**MODIFICATIONS IN THE TILTING TEST PROPOSED FOR THE
DETERMINATION OF THE CENTRE OF GRAVITY IN REGULATION 66**

(presented by Spain)

Document TRANS/WP.29/GRSG/2001/5 proposes the inclusion of a new annex 7 in Regulation 66, in order to incorporate the method for determination of the centre of gravity of the vehicle. Two different methods are considered, the lifting and the tilting method.

FIGURE 5

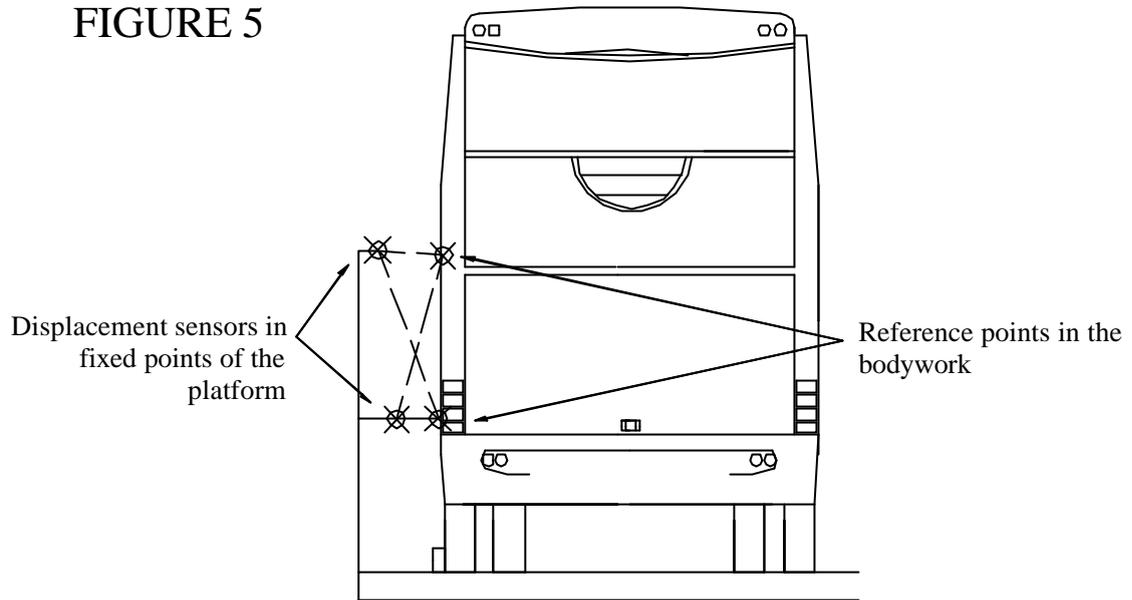
8.4. *Displacement sensors should be placed in fixed points of the platform for positioning the bodywork side wall. The transversal section in which this sensors should be placed will be coincident with CG's longitudinal position (see Figure 5).*

➤ New figures 5, 6 and 7 should be inserted, to read:

FIGURE 6

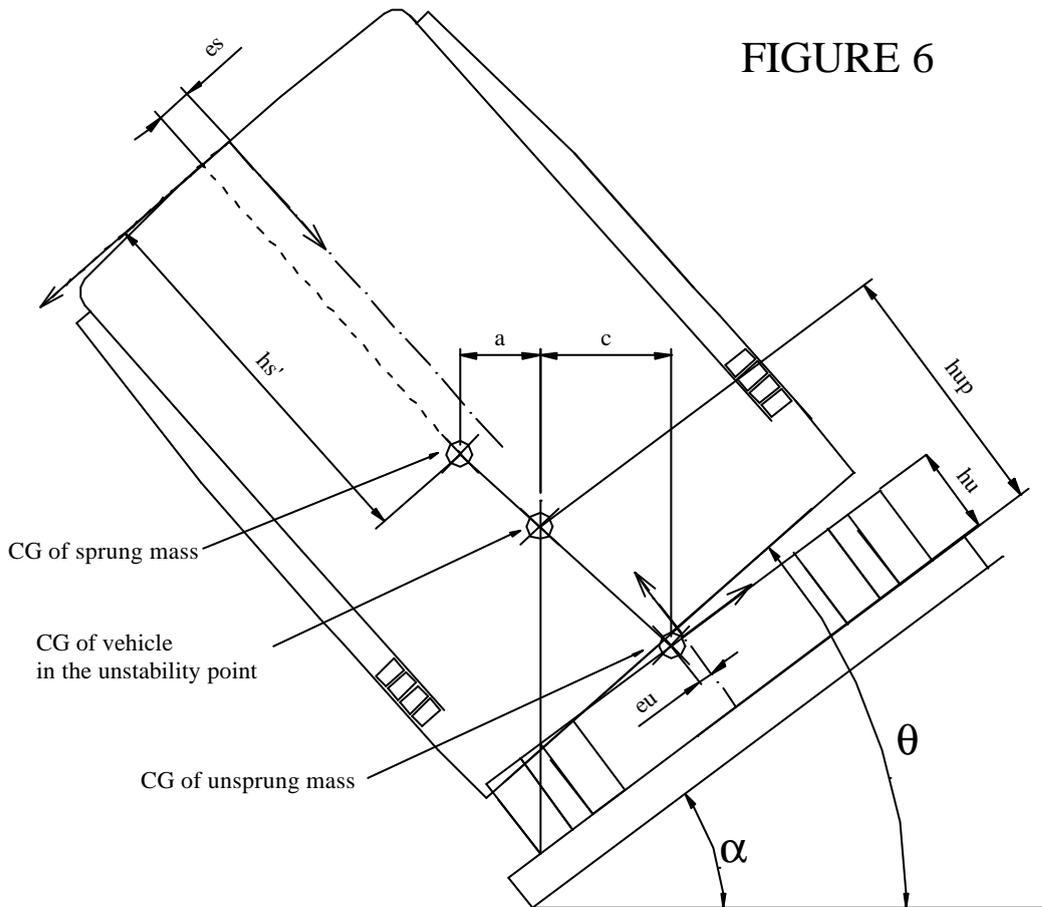
8.8.3. The bodywork position must be drawn at the instability point, just before rollover occurs, as shown in figure 6. Assumed the total CG being in the vertical of the wheel support point, the sprung mass CG position in a reference fixed in the bodywork (h_s'), is graphically obtained as the one making true next relation:

$$a = \frac{m_u}{m_s} \cdot c$$

The real CG's height of the vehicle at the unstable position (h_{up}) may be obtained too.
